MEMORANDUM

To: City of Bayonne Zoning Board of Adjustment

Re: **161 Broadway, LLC, Application Z-23-004**
Use Variance, Major Site Plan and Bulk Variances
Block 330, Lot 12
161 Broadway
Broadway Business District of the 8th St. Station Rehabilitation Area Plan
C-1, Neighborhood Commercial District

Date: October 11, 2023

Image of Existing Storefront with Elements Protruding into Right-of-Way (left), and Applicant’s Survey with Protruding Elements Indicated in Red.

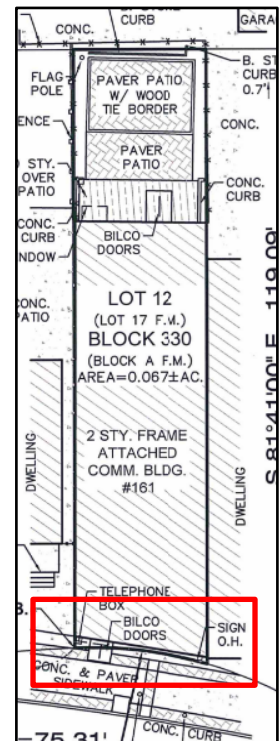
- 1.3. **Encroachments Into City Right-of-Way.** Several parts of the site appear to extend beyond the property line into the City right-of-way. The site plan and survey indicates that the building encompasses the width of the property, however, the front of the building appears to extend into the right-of-way. This area includes

the sign, Bilco doors, phone box, roll-out gate, and portions of the storefront. It appears most of these elements, excepting the Bilco doors, will be removed.

- 5.I.** As indicated in Comment 1.3 of this report, elements of the façade protrude into the right-of-way. Most of these elements, excepting the Bilco doors, appear slated for removal. The applicant should testify as to whether any of the façade element will protrude into the right-of-way and include an exhibit during testimony clearly indicating this one way or the other. It is noted that some elements of the Broadway Business District design standards encourage such protrusions, though a licensing agreement should be brought before Municipal Council such that any

use of the right-of-way is done legally. If such protrusions enhance the aesthetics of the building in a manner consistent with the design standards, it is recommended that the applicant seek the appropriate approvals to permit same.
